LARRY SCRIVANICH
SCRIVANICH PROPERTY
 INTEGRATED DEVELOPMENT PLAN

Planned Unit Development - Modification request

MODIFICATION OF RETAINING WALL/FENCE HEIGHT SUMMARY--PLANNING OFFICIAL DECISION

Project Name: Scrivanich Retaining Wall and Fence Modification Request

EX-01
 SHEET 1 OF 2

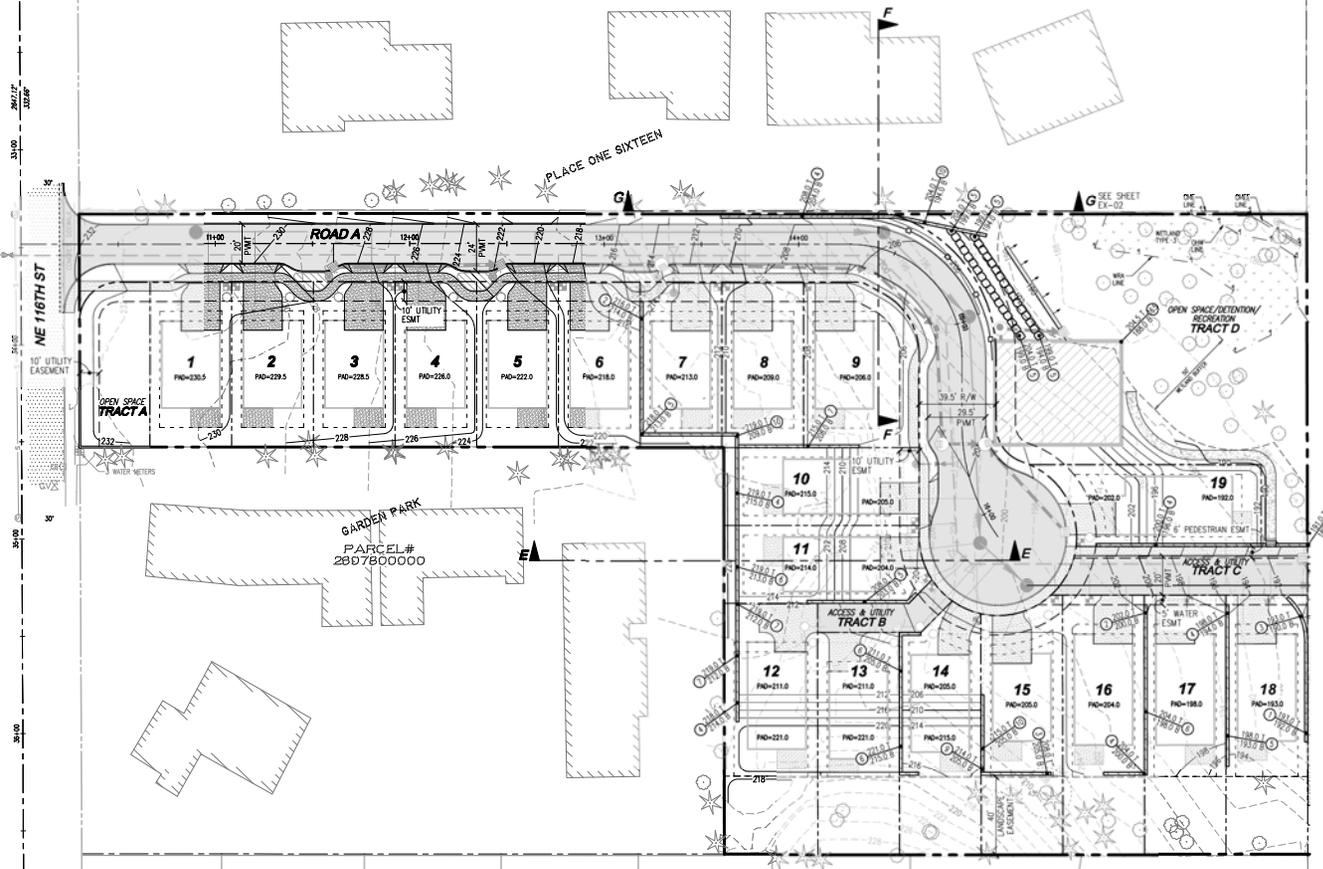
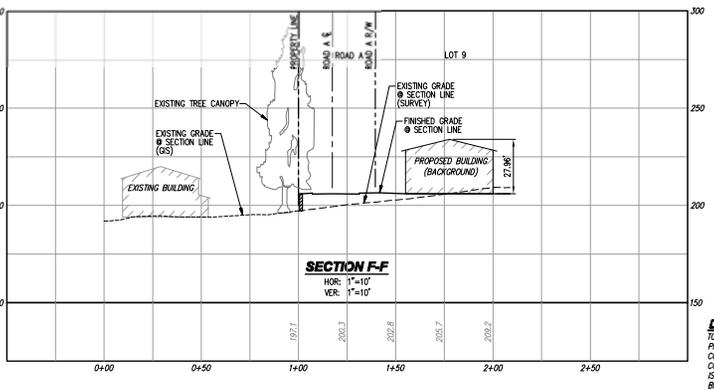
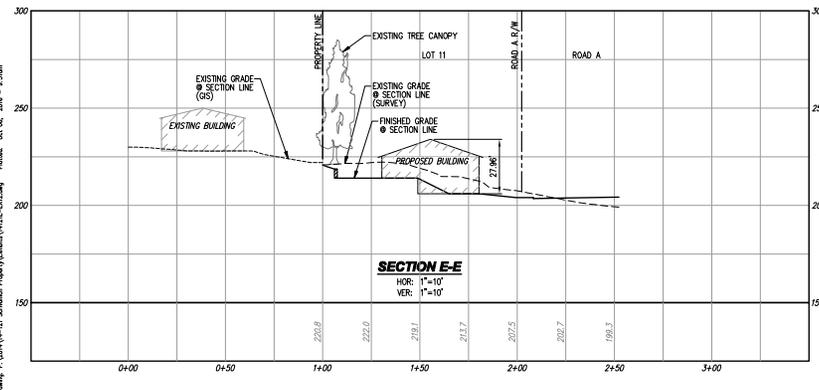
- a) The distance between the proposed retaining wall and homes on the neighboring property is 40' or greater.
- b) The existing fence, as shown on the attached drawing, shows that much of the wall will be behind the fence. As indicated in the attached drawing, the highest point of the wall is on the south end, where it breaks toward the interior of the proposed development so it will be farther away from neighboring properties.

- 1. Retaining wall along the applicant's eastern property line. KZC 115.115.3.g allows a maximum 4-foot tall retaining wall in required yard. The applicant has proposed to construct a retaining wall that ranges from 4 feet up to a maximum height of 10 feet in a required yard. The proposal includes an exhibit which shows an elevation view of the proposed 10-foot retaining wall behind a neighboring development's 6-foot tall fence (See

The applicant has described that because of the topography of the site, the city requirement that the road on the be placed along the east property line, the narrow shape of the site, a retaining wall is required in the proposed location to support a road serving 19 homes. Furthermore, only a portion of the retaining wall is visible behind an existing 6-foot tall fence on the eastern property line. There is also a 40-foot wide landscape easement with large native trees on the neighboring property to the east, which could also be planted with vegetation to make the proposed retaining wall less visible. The overall impact of a 10-foot tall retaining wall is minimized because it will be screened by a 6-foot tall fence, existing vegetation, and a 40-foot landscape easement. Therefore, the modification will not have a substantial detrimental effect on the neighboring properties or the City as a whole.

I approve the proposed modification as proposed. The conditions of approval are found at the beginning of this report. The approval of this modification does not release the applicant from satisfying provisions of Chapter 115.
